## VANGUARD 6435 and 6455 HARDWARE ADVISORY NOTICE

### Installing a Ferrite Bead on a 6435 and 6455

**Figure 1. Installing a Ferrite Bead on an Audio Cable**

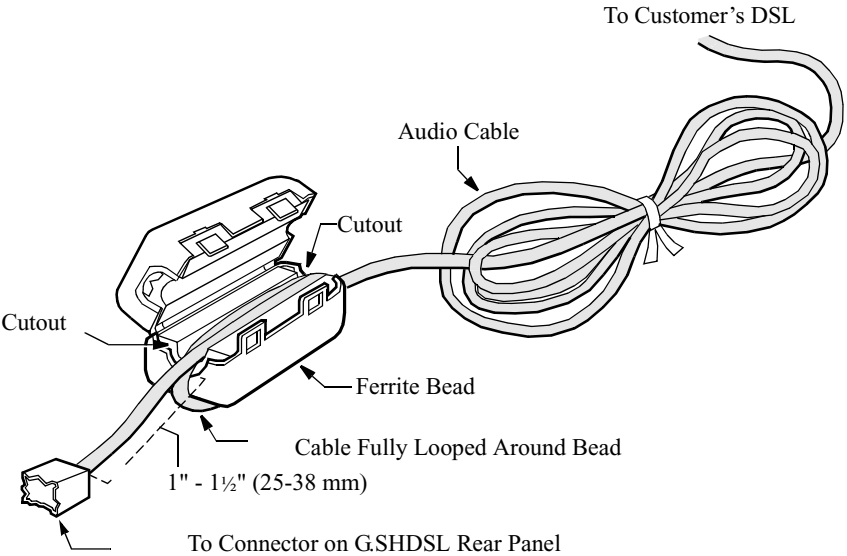
This notice explains how to install a ferrite bead, which filters out line disturbances, on audio and power cables. Installation of a bead is required to ensure compliance with the European Union (EU) EMC Directive 89/336/EEC and compliance with FCC Part 15, Class A. Failure to install the ferrite component will result in non-compliance with the EU EMC Directive and may cause interference with other electrical equipment.

<b>Step</b>	<b>Action</b>
<b>1</b>	Snugly wrap the cable twice completely around the bead (see Figure 1).
<b>2</b>	Set the cable into the bead cutouts.
<b>3</b>	Ensure 1 to 1-1/2 inches (25 to 38mm) of the cable protrudes from the bead (on the end you insert into the G.SHDSL Daughtercard's rear panel connector).
<b>4</b>	Snap the bead closed. You can re-open and close it to re-set the cable.
<b>5</b>	Insert the cable into the appropriate connector on the rear of the G.SHDSL Daughtercard (with the ferrite bead closest to the Daughtercard's rear panel connector).
